**CITY OF LA VISTA**  
**MAYOR AND CITY COUNCIL REPORT**  
**AUGUST 21, 2018 AGENDA**

<b>Subject:</b>	<b>Type:</b>	<b>Submitted By:</b>
APPLICATION TO AMEND PUD SITE PLAN – LB SOUTHWEST, LLC LOTS 1 AND 2, WOODHOUSE PLACE	◆ RESOLUTION ◆ ORDINANCE RECEIVE/FILE	ANN BIRCH COMMUNITY DEVELOPMENT DIRECTOR

CASE NUMBER: PPUD-18-0003

RE: Planned Unit Development (PUD) Amendment  
Initial Review  
Woodhouse Place

# PLANNED UNIT DEVELOPMENT SITE PLAN

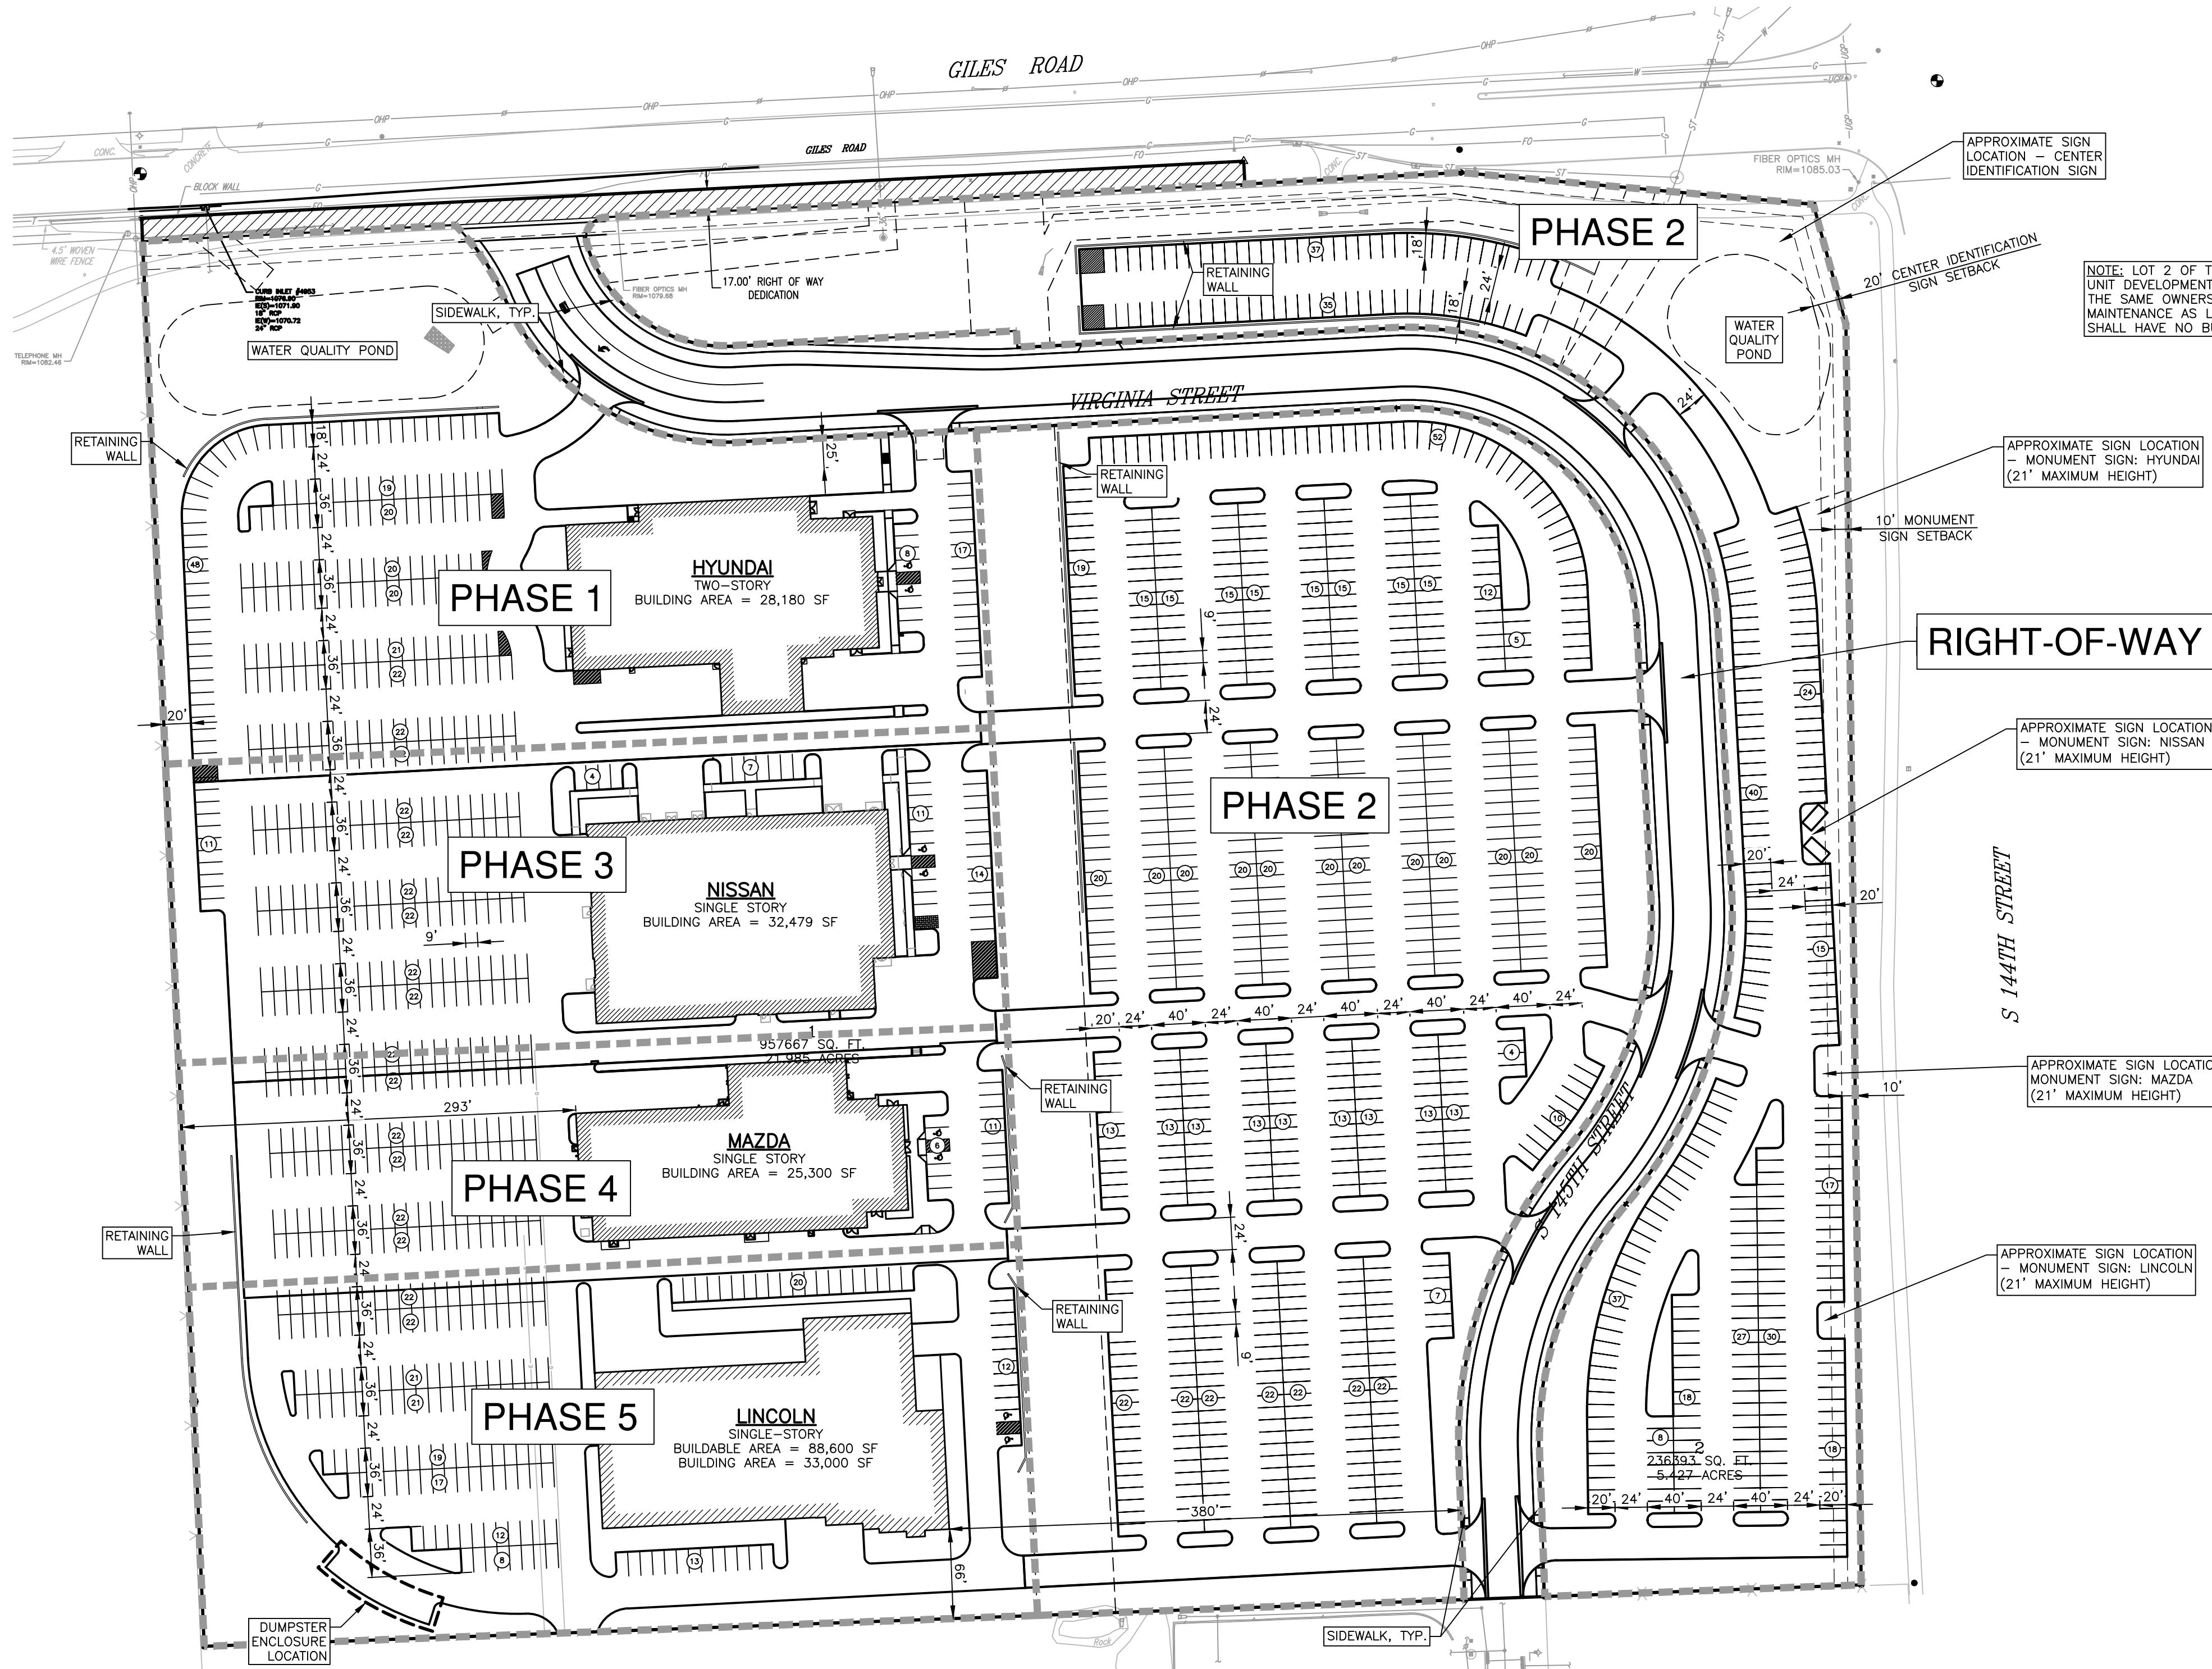
1. The proposed water quality basins should be shown on the PUD site plan. Just the outlines of the basins and the easement areas would be sufficient.

2. Any proposed outside dumpsters should be located on the PUD site plan. Previous communications indicated there would be one at the south end of the project.

3. The amendment should update the building configurations and sizes to the most current information, as there have been some changes since the initial PUD approval.

**RESPONSE:** The water quality ponds have been indicated as requested.

**RESPONSE:** The enclosed dumpster locations have been indicated as requested.

**RESPONSE:** The building footprints shown on the updated site plan are current. If modifications to the Lincoln dealership are made, a future PUD minor amendment will be submitted prior to building permit.
